Access Compliance Report

Public Rights-of-Way

Intersection ID: 18269	Main Street: MCLAUGHLIN_DR	Cross Street: PINAFORE_DR	Location: SE
ADA ID: 175CD5818A99	Ramp Type: PerpDiag	Initial Pass/Fail: Fail	Overall Compliance: No
		Severity Score: 12.5

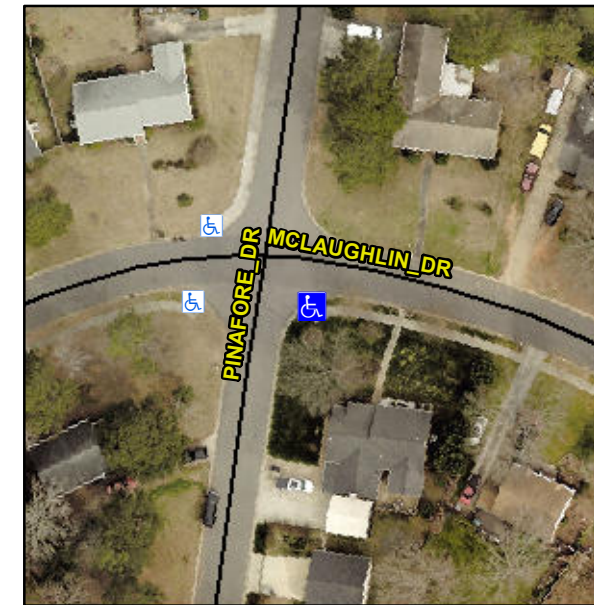
Compliance	Description	Data	Compliance	Description	Data
N/A	Ramp Length (in)	108.0	No	Ramp Slope (%)	8.6
Yes	Ramp Width (in)	48.0	Yes	Ramp XSlope (%)	1.3
N/A	Flare Type LT	N/A	N/A	Flare Type RT	N/A
N/A	Flare Slope LT (%)	N/A	N/A	Flare Slope RT (%)	N/A
N/A	Flare Traversable LT?	N/A	N/A	Flare Traversable RT?	N/A
N/A	Landing Length (in)	N/A	N/A	DWS Provided?	N/A
N/A	Landing Width (in)	N/A	N/A	DWS Contrast?	N/A
N/A	Landing Slope (%)	N/A	N/A	DWS Length (in)	N/A
N/A	Landing X Slope (%)	N/A	N/A	DWS Full Width?	N/A
N/A	Landing Curb? (Y/N)	N/A	N/A	DWS Offset (in)	N/A
N/A	Shared Landing?	N/A			
N/A	Gutter Ponding?	N/A	N/A	Gutter Slope (%)	N/A
N/A	Gutter Lip Ht (in)	N/A	N/A	Gutter X Slope (%)	N/A
N/A	Painted X Walk1?	No	N/A	Painted X Walk2?	No
	X Walk 1 Direction	To N		X Walk 2 Direction	To W
N/A	X Walk 1 Width (in)	N/A	N/A	X Walk 2 Width (in)	N/A
	X Walk 1 Slope (%)	6.9		X Walk 2 Slope (%)	6.2
	X Walk 1 X Slope (%)	6.3		X Walk 2 X Slope (%)	7.5

N/A	Ramp inside XWalk1?	N/A	N/A	Ramp inside XWalk2?	N/A
	Road Slope (%)	1.2	N/A	Clear Space?	N/A
	Road X Slope (%)	8.0	N/A	Clear Space to XWalk (in)	N/A
N/A	Any Obstructions?	N/A	N/A	Storm Grate/Utility Hazard?	N/A
	Obstruction Type			Storm Grate/Utility Type	
		N/A			N/A
			Yes	Surface Condition? (G/P)	Good

Remove & Replace Curb Ramp With Two New Directional Ramps or Equivalent.
